Notice of variation with introductory note

SI Green UK Limited

Variation application number
EPR/TP3835LV/V003

This variation is to add an additional point source emission to water and update the surface water management plan.

Amended plan attached

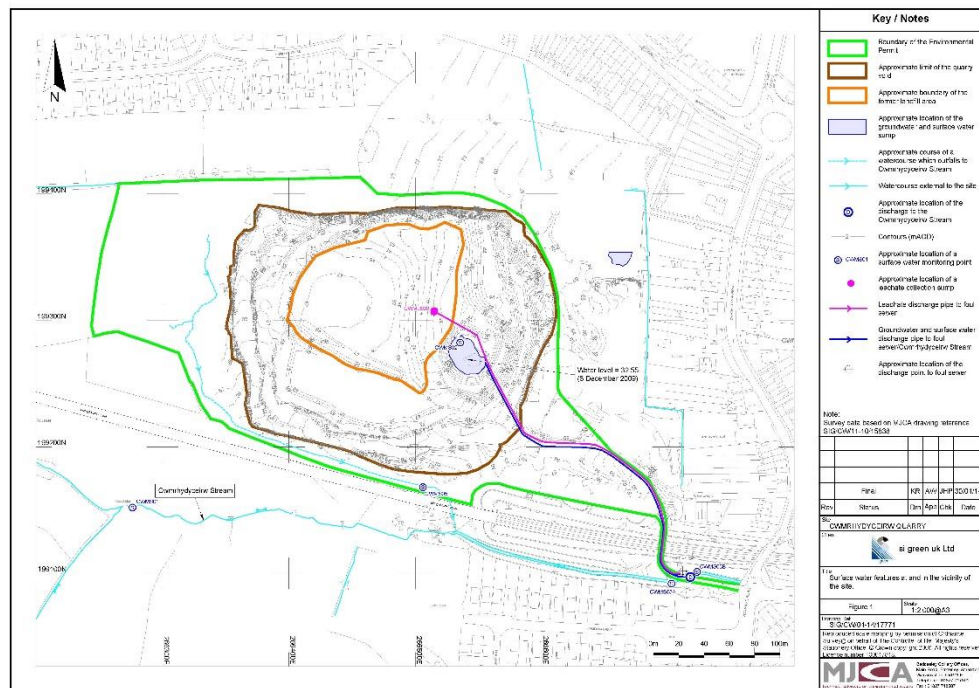
The new point source emission to water will enable groundwater and surface water to be discharged directly to Cwmrhydyceirw Stream. Table S4.3 of the permit has been updated to reflect this change. Leachate will continue to be discharged to sewer.
